| APPLICATION NO. | FILING DATE | FIRST NAMED INVENTOR | ATTORNEY DOCKET NO. | CONFIRMATION NO. |
|--|-------------|----------------------|-----------------------------|------------------|
| 09/832,093 | 04/11/2001 | Shigeo Ishikawa | Q64059 | 8684 |

Office Action Summary

DETAILED ACTION

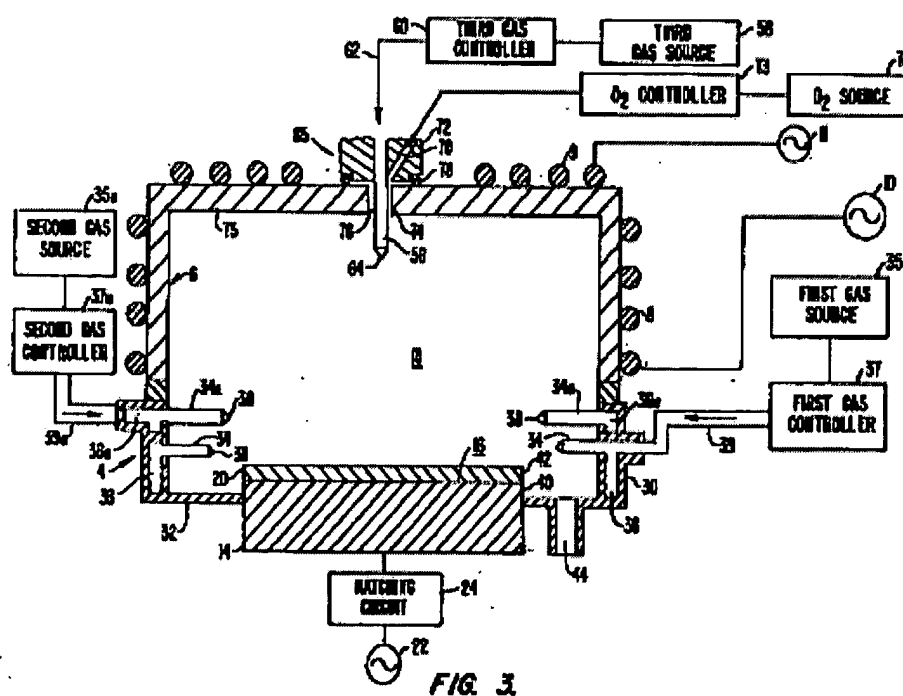
(a) starting a supply of a reaction gas at a first flow rate into a chamber **18** in which a plasma is formed (page 3, paragraph [0024]), such that an initial film is formed on a center region of a wafer **20** via a first nozzle **56** provided on the chamber above the center region of the substrate (page 3, paragraph [0027]) and

(b) starting a supply of the reaction gas at a second flow rate into the chamber in which the plasma is formed via second nozzle **34 and 34a** wherein the second nozzle are

provided on side walls of the chamber above the wafer (page 3, paragraph [0025]), after the step (a), while the supply of the reaction gas at the first flow rate continues such that the oxide film is formed on the initial film (page 3, paragraph [0028], page 4, paragraphs [0035]-[0038] and **FIG. 3**), the first flow rate (36 sccm) being smaller than the second flow rate (44 sccm) (page 4, paragraph [0038]),

Nozzles (56 and 64) positioned over the center of the substrate 20 inherently producing the film on the center region, and

wherein the formation of the oxide film is initiated from the center region of the wafer in the above step (a), and the oxide film is formed on the whole of the wafer in step (b).

Li does not explicitly disclose that the step (b) is carried out 1 to 10 seconds after the step (a) is carried out as recited in the Applicant's claimed invention.

However, there is no evidence indicating the starting time range and the flow rate ranges is critical and it has been held that it is not inventive to discover the optimum or workable range of a result-effective variable within given prior art conditions by routine experimentation. See MPEP § 2144.05. Note that the specification contains no disclosure of either the critical nature of the claimed dimensions of any unexpected results arising there from. Where patentability is aid to be based upon particular chosen dimensions or upon another variable recited in a claim, the Applicant must show that the chosen dimensions are critical. In re Woodruff, 919 F.2d 1575, 1578, 16 USPQ2d 1934, 1936 (Fed. Cir. 1990).
